According to provisions of 10 CFR 2.206, I hereby petition the NRC to perform *de novo* reviews of ballooning (swelling) and rupture models used in licensees' loss-of-coolant accident analyses required by 10 CFR 50.46, and further to require licensees to incorporate any modifications needed to obtain NRC approval and then use only such models that have been so reviewed and approved by the NRC in all such licensing analyses.

The Issue

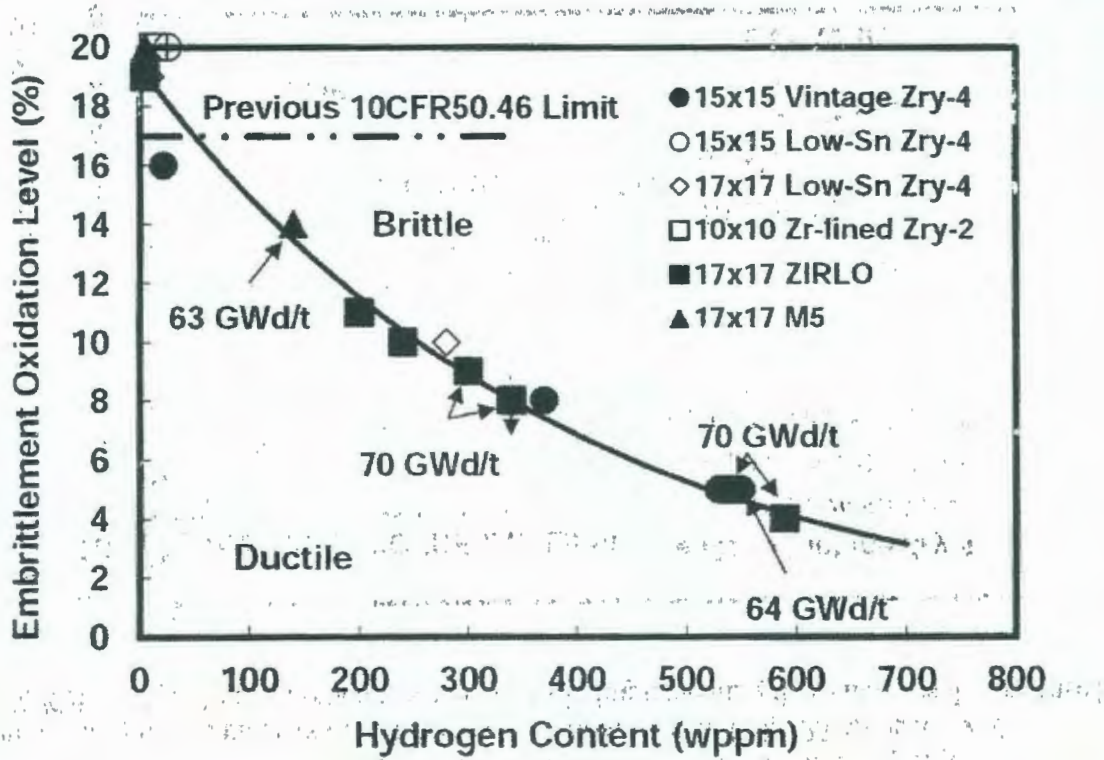
Recent research results show that the limiting oxidation level for high-burnup fuel will be far below the 17 percent limit prescribed by 10 CFR 50.46 as seen in the following figure (unnumbered figure on page xxxii of the Executive Summary and Fig. 25 on page 59 of NUREG/CR-7219). Relaxed schedules and delays in implementing these new results are based

on a safety assessment and audit which confirmed that sufficient safety margin exists for operating reactors and determined that immediate regulatory action was not required (Clifford to Ruland, February 10, 2012, ML12041A078). This assessment was based on industry calculations with models that may be flawed because of inadequate ballooning and rupture models.

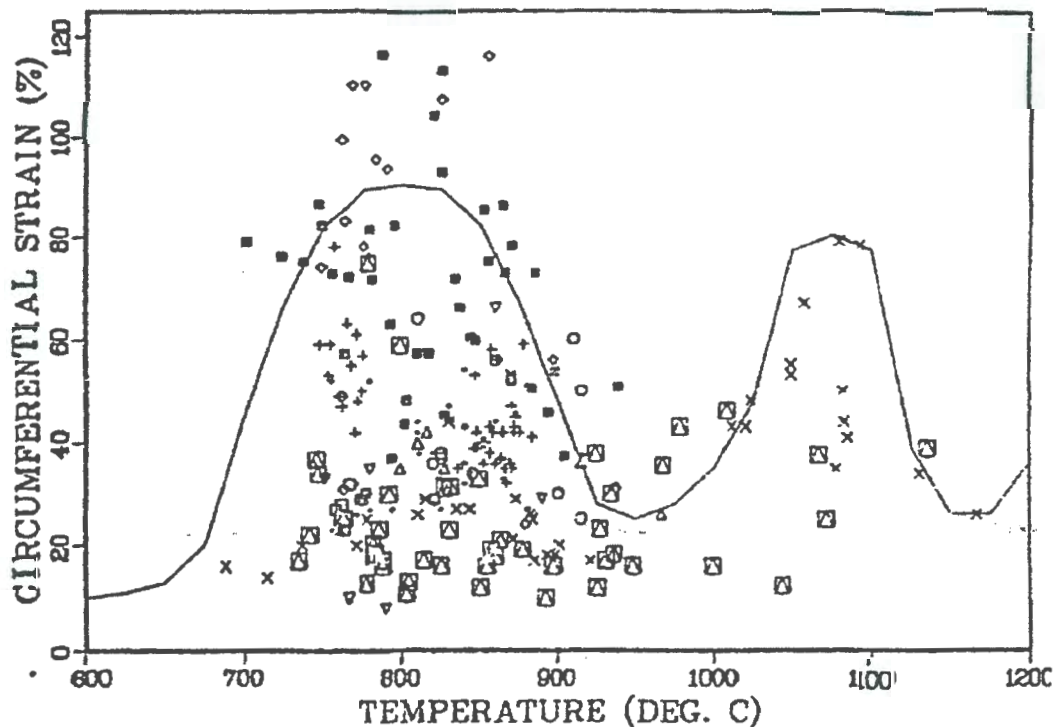
In light of recent research results, the ballooning and rupture models used in licensing analyses to calculate ECR are probably non-conservative. The basis for this statement can be explained with the following figure from NUREG-0630. This figure shows the size of the balloons (larger balloons have thinner walls) as a function of rupture temperature for fresh or low-burnup Zircaloy. There are two peaks: alpha-phase cladding on the left and beta-phase cladding on the right. The valley in the middle is in the mixed-phase region. It was previously believed that fill pressures could be engineered such that rupture would occur in the mixed-phase valley and therefore balloons would be relatively small. Most or all current ballooning and rupture models used in licensing predict relatively small balloons. This was not considered a concern by NRC because ECR was seldom if ever limiting and a more critical review seemed unnecessary.

The second finding is that the peaks-and-valley character of balloon size, as shown in the above figure, shifts along the temperature axis with the addition of niobium to zirconium in the more modern ZIRLO and M5 cladding materials. Although we now know that niobium causes a shift, there are not enough data to define the new peaks and valley for ZIRLO and M5 such that one could claim that ruptures only occurred in the valley.

Finally, one should recognize that the curve drawn through the scattered data in the above figure is a best estimate and was not intended as a conservative representation of the data. As an author of that report, I know that many of the tests that resulted in smaller balloon sizes had atypical test conditions that biased their results. Therefore, we drew the best-estimate curve through the larger balloon sizes. Thus, any model that predicts ballooning strains less than about 90%, based on the above figure, should be suspected of being non-conservative.

It is well known that rupture results from a plastic instability that is set off by local temperature hot spots. There are many causes of local temperature variations that lead to the unpredictable character of the rupture process, as seen in the large data scatter in the above figure. Mechanistic models cannot represent the stochastic nature of this process. Therefore a statistical approach, which represents all of the data without favoring strains in the mixed-phase valley, is probably needed and should provide some modest conservatism of the ensemble of data.

In performing a *de novo* review of current ballooning and rupture models, it is important to utilize results from tests that were performed with internal heating to determine the magnitude of ballooning strains. External heaters can significantly bias the results, as discussed in NUREG-0536 and NUREG-0630. Heating methods that utilize furnaces or ovens can generate atypically uniform temperatures that will result in balloons that are too large. Heating methods that utilize discrete external heat sources, such as the quad-elliptical furnace used recently in NRC research, can generate atypically non-uniform temperatures that will result in balloons that are too small. As reported in NUREG/CR-7219, such a furnace was perfectly adequate for producing balloons whose properties could be studied, but would not be adequate for determining expected balloon sizes. Unfortunately, there are probably not many more qualified data beyond those reported in NUREG-0630, but a careful search for additional data should be made.
